RICAP 5**AMENDMENTS ADOPTED BY COUNCIL FEBRUARY 11, 2010**

RE: **RICAP 5: Remaining Decisions**

ATTACHMENT N — LOTS IN THE R5 ZONE/PLAs

NEW Figure 667-1
Property Line Adjustment on Corner Site in R5 Zone

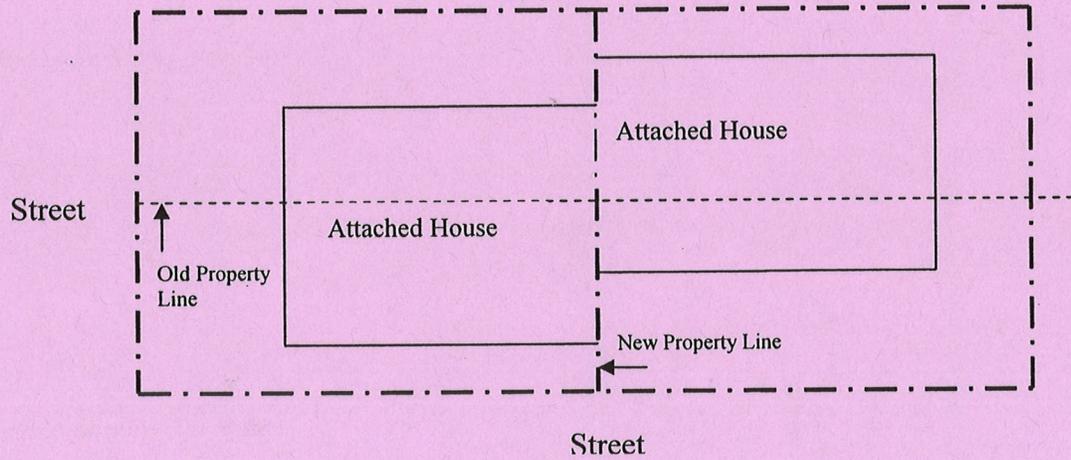
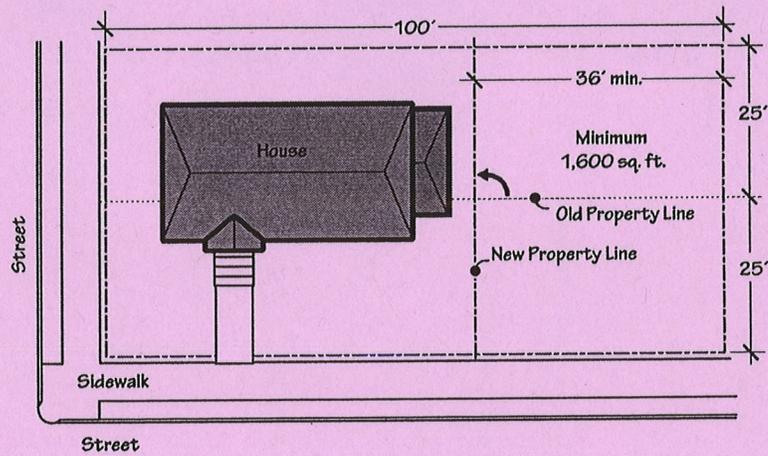
- Move to amend the Recommended Draft as shown in Attachment N, dated March 4, 2010 (allow nonconforming lots on corners to reduce size to 1600 sq ft and 36 ft wide through a PLA if lot lines are perpendicular and setbacks are either met or modified through design review. In addition, clarify that attached or detached houses are allowed and that 33.110.213 applies)

- A. Properties.** For purposes of this subsection, the site of a Property Line Adjustment is the two properties affected by the relocation of the common property line.
 1. ~~The properties will remain in conformance with Property Line Adjustment will not cause either property or development on either property to move out of conformance with any of the regulations of this Title, including those in Chapters 33.605 through 33.615 except as follows:~~
 - a. If a property or development is already out of conformance with a regulation in this Title, the Property Line Adjustment will not cause the property or development to move further out of conformance with the regulation;

- b. If both properties are already out of conformance with maximum lot area standards, they are exempt from the maximum lot area standard; and
- c. If one property is already out of conformance with maximum lot area standards, it is exempt from the maximum lot area standard; and
- d. If at least one lot is already out of conformance with the minimum lot area standards and the site is in the R5 zone, the minimum lot area is 1600 square feet and the minimum width is 36 feet, if:
 - (1) At least one lot is a corner lot;
 - (2) The adjusted property line must be perpendicular to the street lot line for it's entire length; and
 - (3) New houses must meet the standards of 33.110.213. Existing houses are exempt from the standards of 33.110.213.

**NEW Figure 110-15
Retaining Walls**

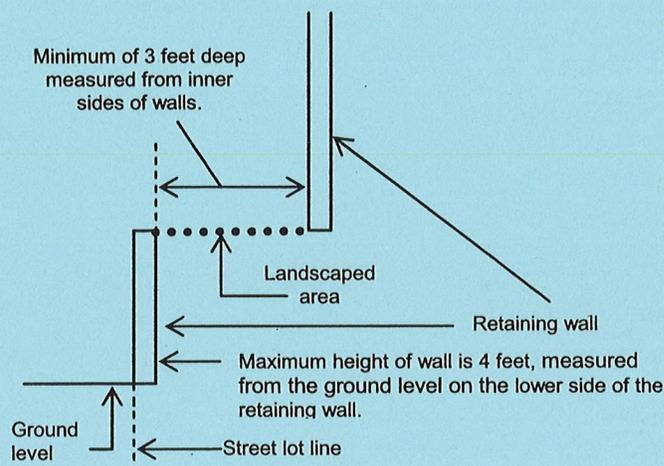
1. Retaining walls must include a step-back as shown in Figure 110-15.
2. The landscaped area shown in Figure 110-15 must be landscaped to at least the L2 standard, except that trees are not required. A wall or berm may not be substituted for the shrubs.

Motion regarding retaining walls to adopt the language in Attachment D, dated February 5, 2010, with a sunset of six months; and move to refer this issue to the Planning Commission for a public hearing and their recommendation: Moved by Commissioner Fish and seconded by Commissioner Saltzman. (Y-5)

Existing Lots in R5

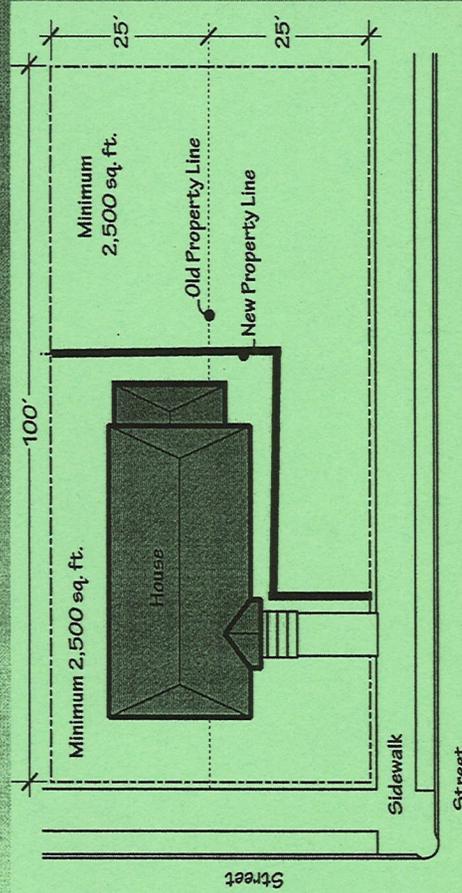
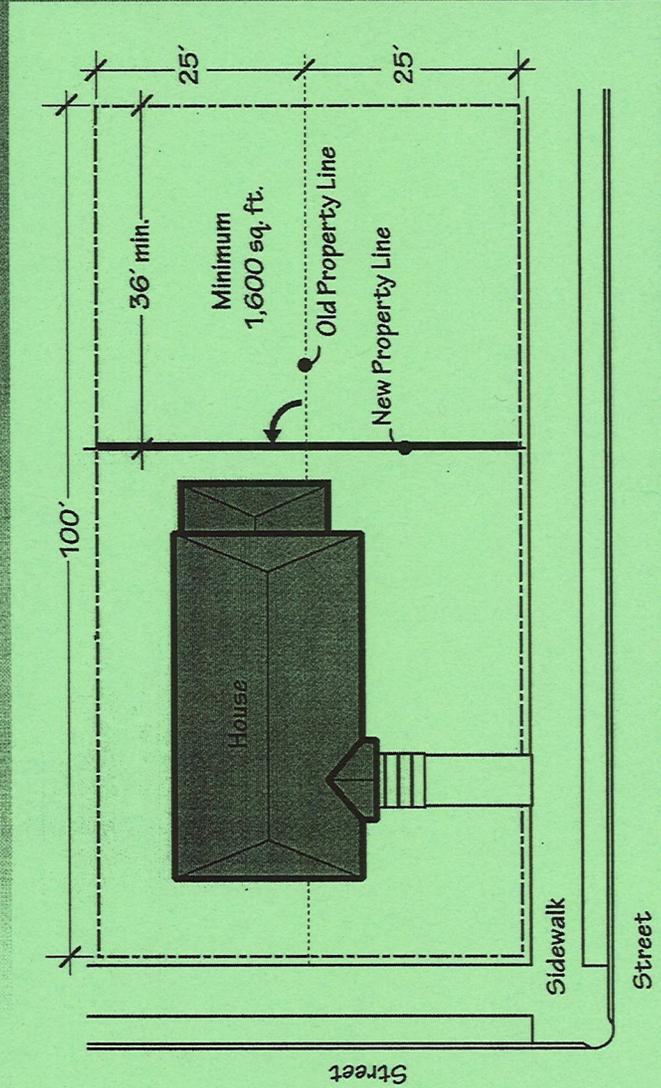
Relocated lot line under current standards.

Relocated lot line after amendment.
